REGIONAL REVIEW NOTIFICATION

ARC REVIEW CODE: R1708151

Name of Proposal: Friendship Village (DRI 2686)

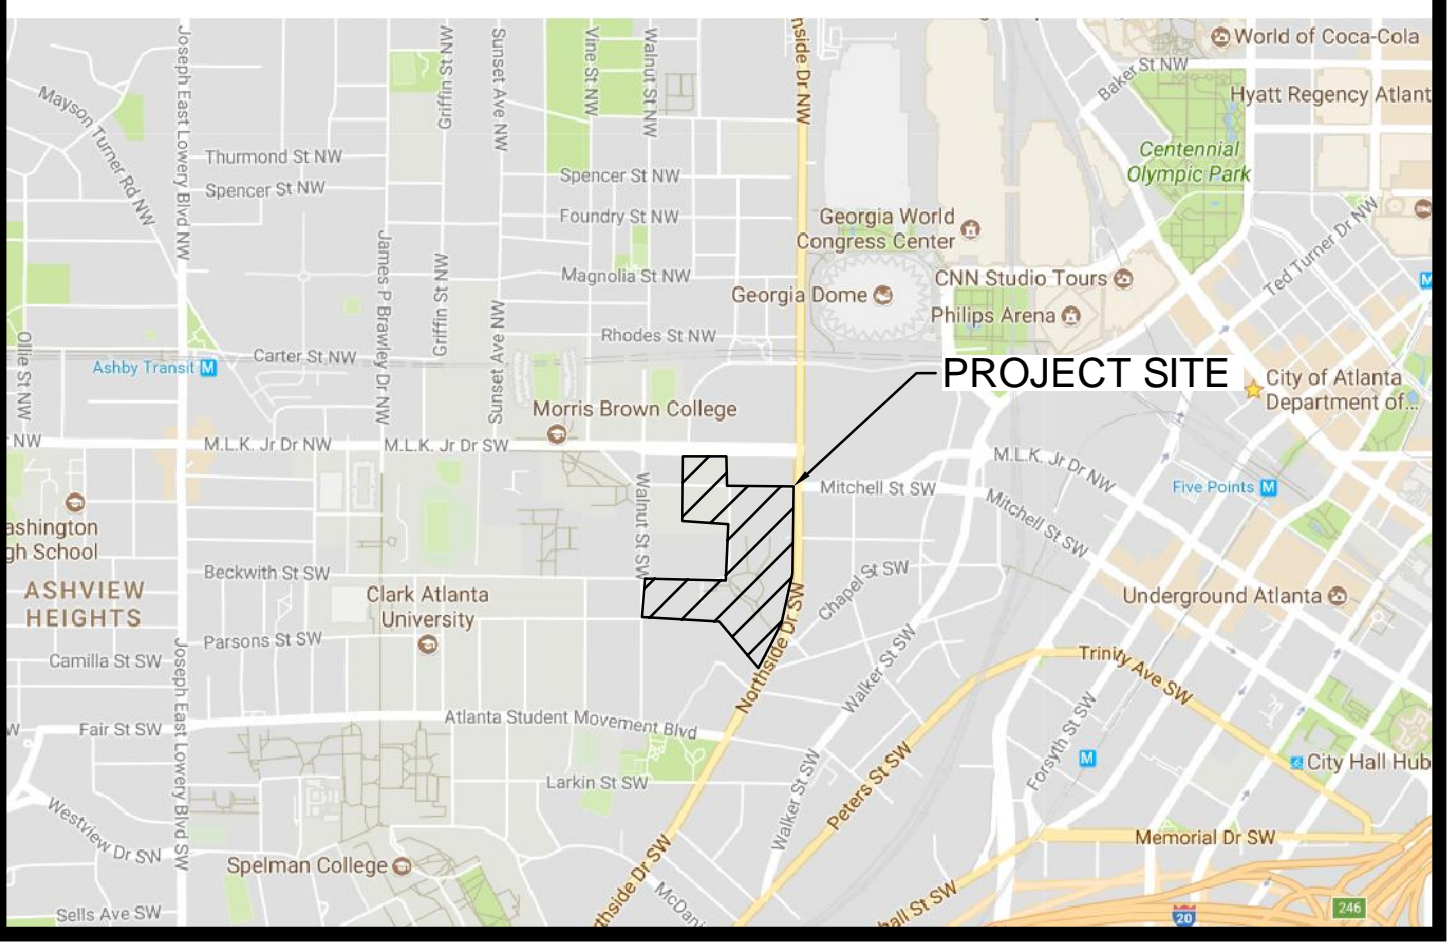
The transportation analysis and site plan shows proposes eleven driveways throughout the site providing inter parcel connectivity.

The site plan and traffic analysis shows proposed pedestrian improvements to existing facilities and construction of new facilities internal to the site allowing for internal pedestrian connectivity

The development proposes additional Access points at Driveway 1 on Walnut Street, Driveways 5, 6, 7 and 8 on Northside Drive and Driveway 9 and 10 on Martin Luther King Jr Drive. Driveway access 8 does not align with the existing access point on Nelson Street presenting safety concerns. Proposed Driveway access 6 creates conflicts with existing access points on the east side of Northside Drive.
